NDS Configuration and Requirements Changes since Nov 2010

Chris Lupo
June 14, 2011

NASA Docking System (NDS) Block 0

NDS APAS Docking Adapter (NADA)

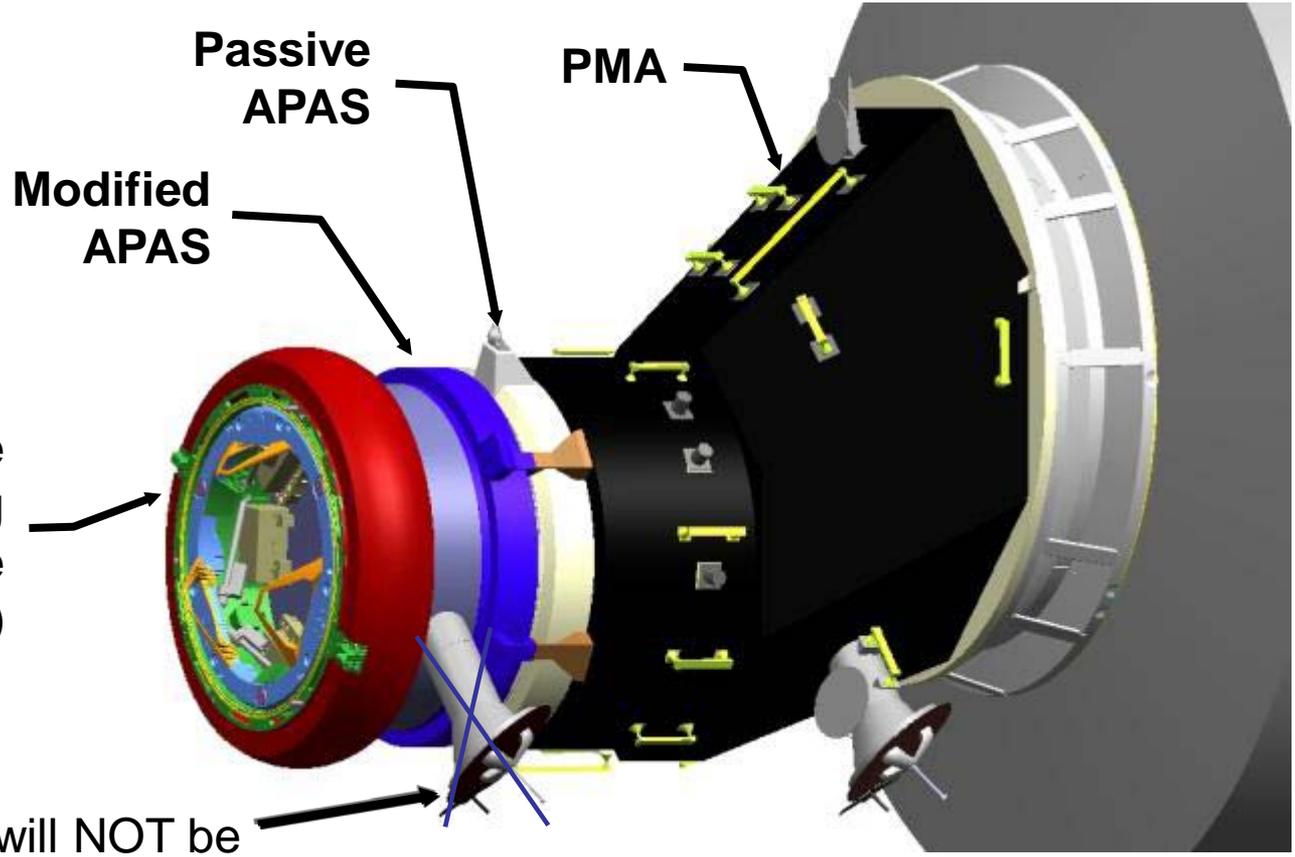
Grapple Fixture will NOT be Included for this concept

- ◆ Configuration Baseline Description
 - The host bolt circle diameter and number of bolts shall match the APDA interface. The hole pattern must match APAS but the edge distance and clearance hole size may be adjusted if necessary for NASA load cases. The bolts and shear pins shall be metric. The shear features may be different than the APAS.
 - Update IDD to modify flange thickness for NDS tunnel, seal groove dimensions, shear pin location, and miscellaneous tolerances to match tunnel drawing SDZ29101974.
 - In addition update IDD based on mated interface analysis as follows. Host flange minimum = .75 in. Update insert drill depth to be consistent with minimum host flange thickness. Loosen tolerance on alignment slot for drill template.
- ◆ Approval: DSIP 6/1/11
- ◆ Incorporation: Pending NDS IDD Rev E

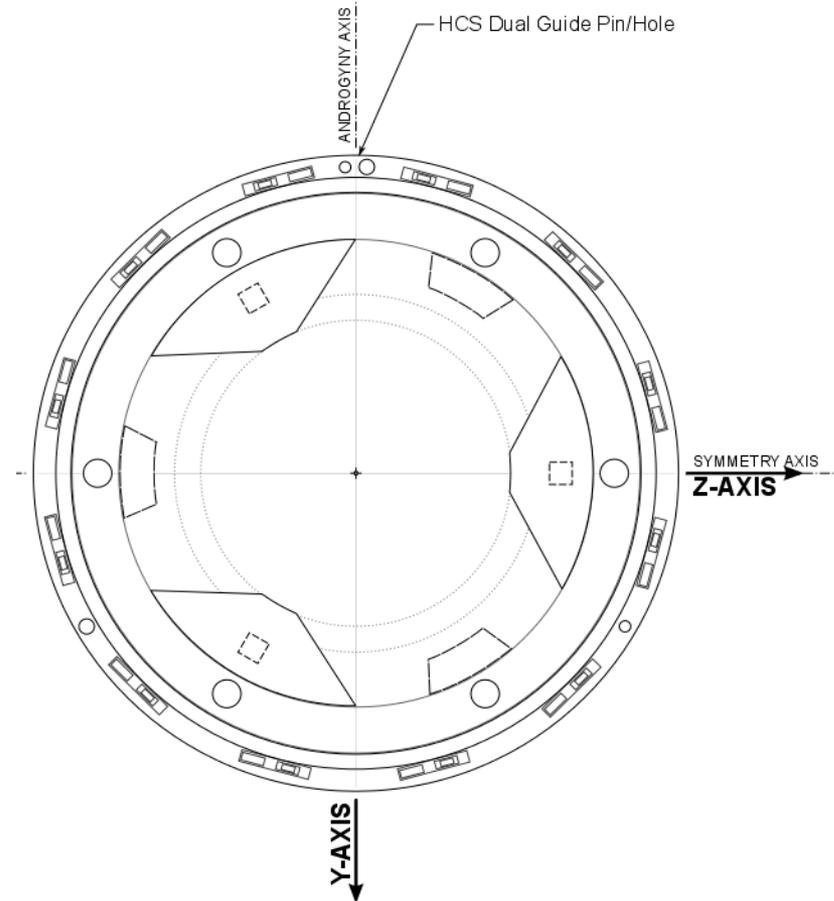
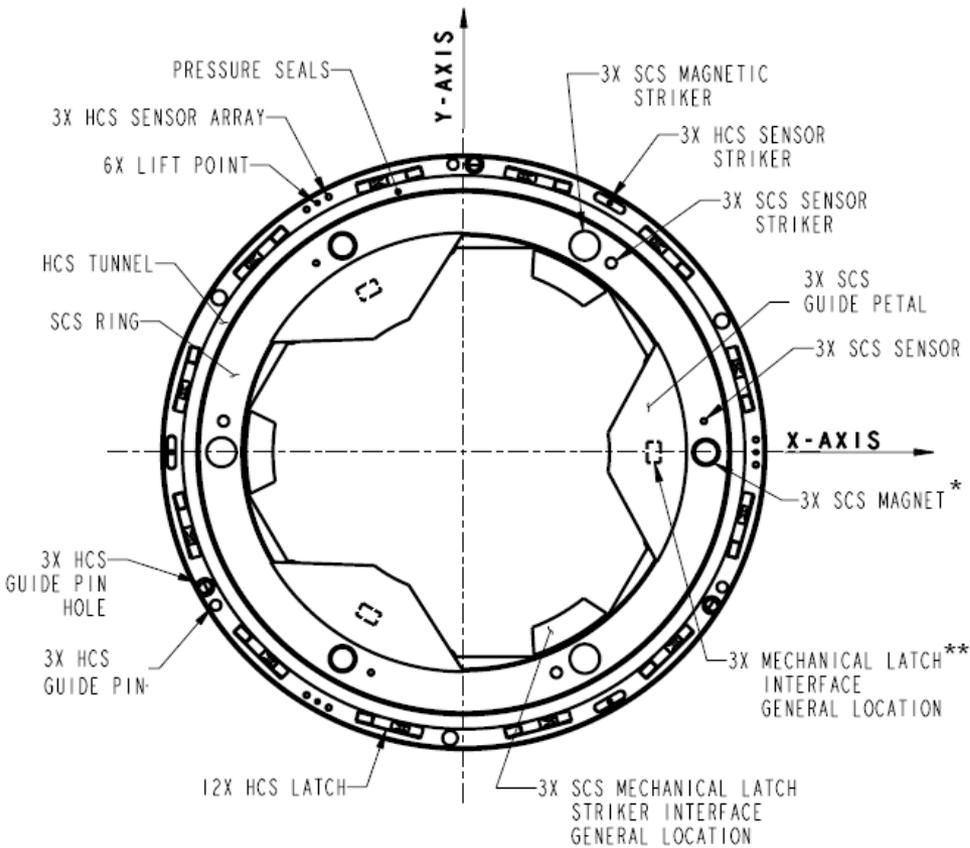
- ◆ Configuration Baseline Description
 - IDSS IDD Rev A does not specify a coordinate system. NDS IDD coordinate system does not meet classical approach for structures or GN&C. Update NDS IDD to have two coordinate systems with the classical approach.
 - See following charts for recommended coordinate system change
- ◆ Approval: DSIP 6/1/11
- ◆ Incorporation: Pending NDS IDD Rev E and tunnel drawing revision

Proposed Head for all 8
Return to
[NDS Interface Change Summary](#)

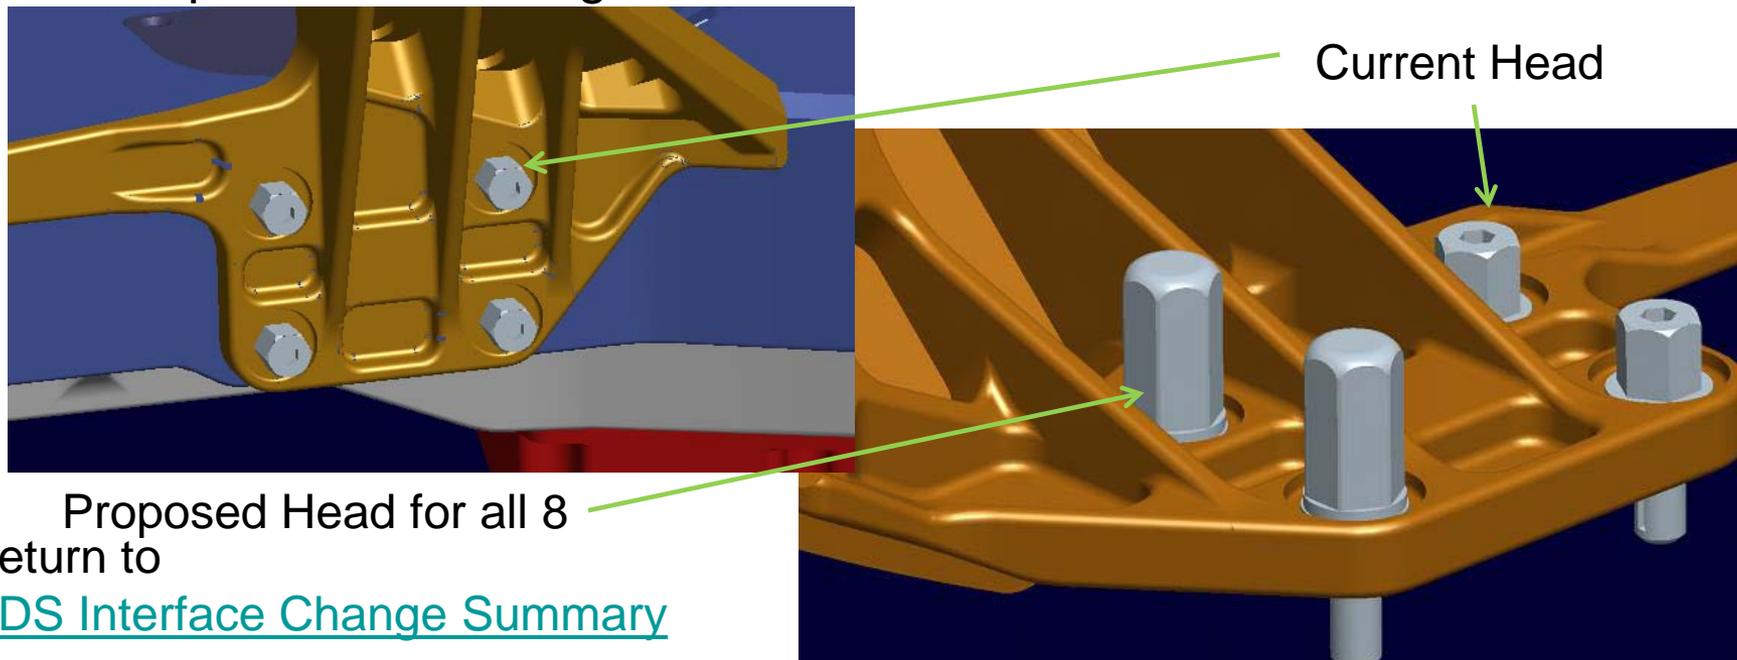
- ◆ RID CDR-8, 21 and 22
 - Guide Petals are IVA removable. Although there is no requirement for EVA access, the crew requested and the board approved a design change to 7/16 double height hex.
 - Modified locking feature to support multiple removal cycles for ISS
 - Ensure fasteners are compatible with IVA tool box SEG33113668-301
 - Deleted specific IVA compatibility requirements from PTRS
- ◆ Approval: CDR Board 5/9/11
- ◆ Incorporation: Pending NDS IDD Rev E
